INDESIT company

LI48A

F027246

n1045034: New top condenser.

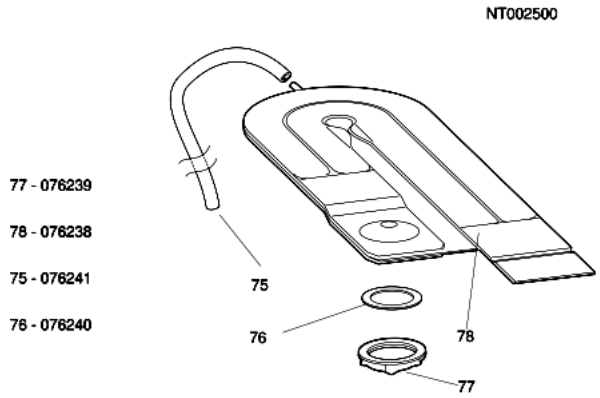
As of the last week in July 2000, the new "Wind drying system" was inserted on some appliances from the new MarckII Range.
This new system foresees the elimination of the lateral air-flow body and the insertion of a new system with top condenser.
The spare part numbers eliminated are as follows:

054927(Rohs 144335) - RING NUT FOR AIR-FLOW BODY
054928 - AIR-FLOW BODY
103689 - NOZZLE GASKET
057874 - TOP SOUNDPROOFING LAYER

Whereas the new spare part numbers are:

076238 - WIND DRYNG SYSTEM CONDENSER
076239 - CONDENSER RING NUT
076240 - TOP CONDENSER GASKET
076241 - TOP CONDENSER PIPE

The new part numbers are not interchangeable with the old ones, as they are completely different. See technical drawing attached to notice NT002500.

n1045055: New turbidity sensors and wiring

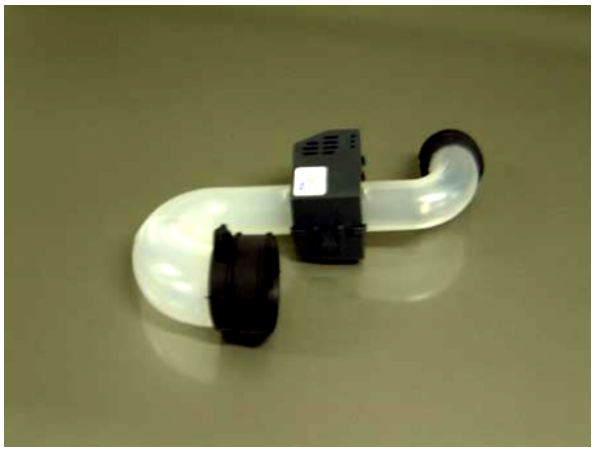
All dishwasher models affected by this modification have been equipped with new turbidity sensors, wiring and electrical circuit.
As regards the turbidity sensor, new sat code 087340 replaces the old sat code 077173.
The following is a list of affected models, serial numbers for new parts, wiring and electrical circuits for respective models.

New wiring 089069 replaces old 080715
New electrical circuit 16001385301
- LI48A commercial code 27246
Serial number 20318.0001
New wiring 089068 replaces old 087809
New electrical circuit 16001445403

Photo N1045062FIG1 illustrates the bottom of the dishwasher with EVO structure.

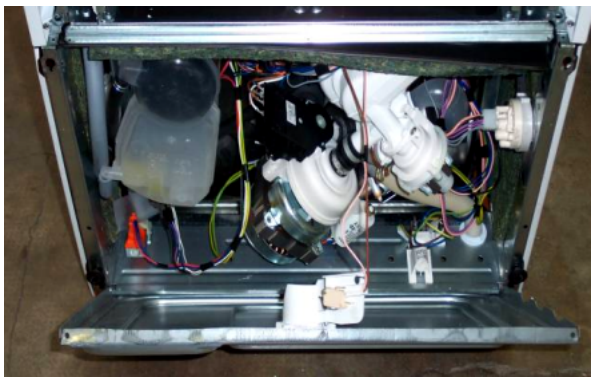
From serial number 30101.0001, all dishwasher models affected by this modification have been produced with EVO structure. These models have been equipped with NEW TRAYS AND NEW FEET (see N1045062TAB1).

EVO STRUCTURE:
Tray: 092558 (for commercial code 28490) 092554 (for commercial code 26043-23520-28088);
Tray rear feet: 092820-092821-092822;
Tray front feet: 092555;
Front feet supports: 065836;
Feet supplied with plinth accessories assembly: 034261.

Regulation assembly DX/SX Sat codes 078397 and 078396 will be managed up to stock end, after that they will be replaced by new Sat codes 092821 and092820. The same is for rear foot Sat code 078385 which will be replaced by Sat code 092822.

n1045063: Introduction of coupling+ring nut Sat code 093752

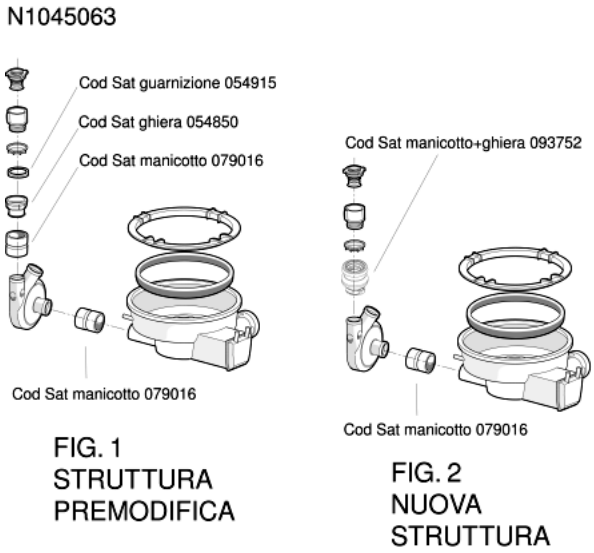
From serial number 30224.0001, all dishwashers affected by this modification have been equipped with the new coupling+ring nut assembly Sat code 093752, in place of coupling Sat code 079016, ring nut Sat code 054850 and gasket Sat code 054915.

Ring nut Sat code 054850 will continue to be available from the spare parts warehouse while stocks last, and coupling Sat code 079016 will continue to be stocked because it is still used for the tank-volute connection.
Picture N1045063 illustrates the premodification structure in FIG1 and the new structure in FIG2.

n1045066: Modification of 8-WAY CABLE Sat code 087051

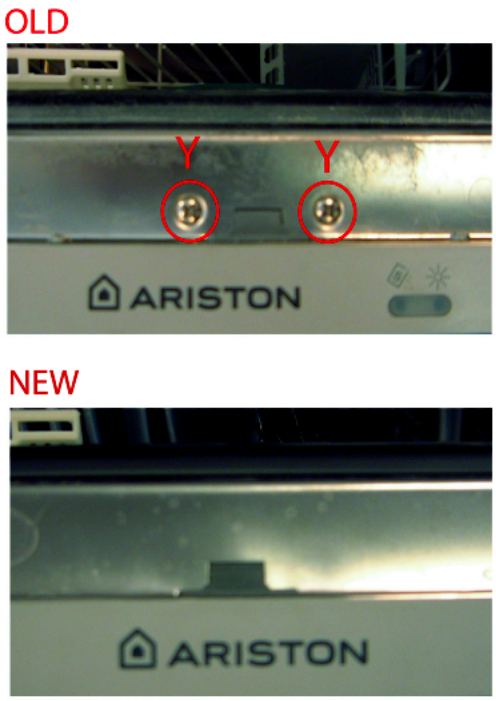
From serial no. 20906.0001, the dishwasher models given below have been fitted with a new 8-WAY CABLE, Sat code 087051. The new cable can be used in place of the premodification one, but not vice versa. The Spare Parts Warehouse stocks have been replenished with the new items.
If the BIT 100 electronic card needs replacing on premodification appliances, the 8-WAY CABLE Sat code 087051 must also be replaced.
The models affected by the modification are:
LI66 comm. code 26861;
LI67DUO comm. code 26551;
LI68DUO comm. code 26590;
LI67DUONL comm. code 27522;
LI68DUOUK comm. code 27249;
LI48A comm. code 27246;
LI46 comm. code 27245;
LI45UK comm. code 27247;
DI45A/B comm. code 18483 (industrial code 37184830200, previous industrial codes are produced with DIWA cards);
DI63A/B comm. code 25537 (industrial code 37255370100, previous industrial codes are produced with DIWA cards).
